CONSERVATION HALTON COMMENTS

Proposed Burlington Quarry Expansion

Interim JART COMMENT SUMMARY TABLE – Hydrogeology

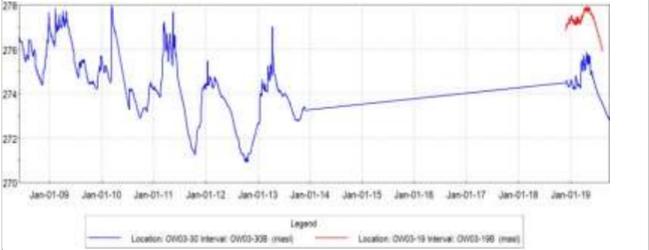
88.	<p>It is impossible to depict some of the monitors on Figure 3.4. Please provide a larger scale map clearly showing all the monitoring location.</p>	<p>The map below shows the well distribution where they are tightly clustered.</p>	<p>Addressed</p>	<p>RESOLVED</p>	<p>RESOLVED</p>
120	<p>How was the subsurface conduit to model the disappearing stream segment represented in the model?</p>	<p>The SFR2 stream segment was assumed to interact (i.e., gain or lose flow to the weathered bedrock) with Layer 4. The stream had a relatively narrow section (same as a Strahler Class 2) and a bed hydraulic conductivity of 1x10-4 m/s compared to normal streams in Layer 1 (5x10-7 m/s).</p>	<p>Addressed.</p>	<p>RESOLVED</p>	<p>RESOLVED</p>

Figure 6.26: Comparison of observed and simulated water levels at monitor **OW03-31** (Note: deep)

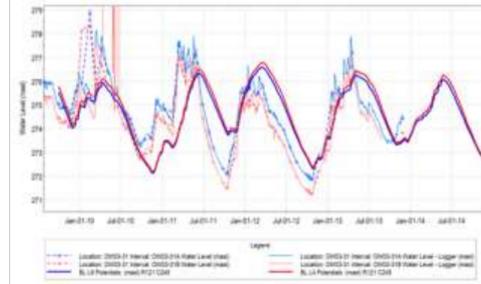
There is a lag between the observed and simulated groundwater water levels.

Please explain.

No response provided by proponent.

Figure 2. Details of the Precipitation-Runoff-Modeling System Soil Zone.

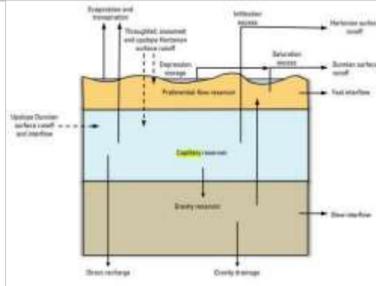
169.	Referring to Figure 6.4, what are the capillary and drainage reservoirs?	Here is a schematic from the PRMS v4 manual. The capillary reservoir accepts infiltration (after canopy interception and Hortonian runoff) and loses water to soil ET. Excess water above the storage capacity of the capillary reservoir (equivalent to above field capacity) goes to the gravity reservoir where flow is portioned into interflow and GW recharge.	No further comments.	RESOLVED	RESOLVED.
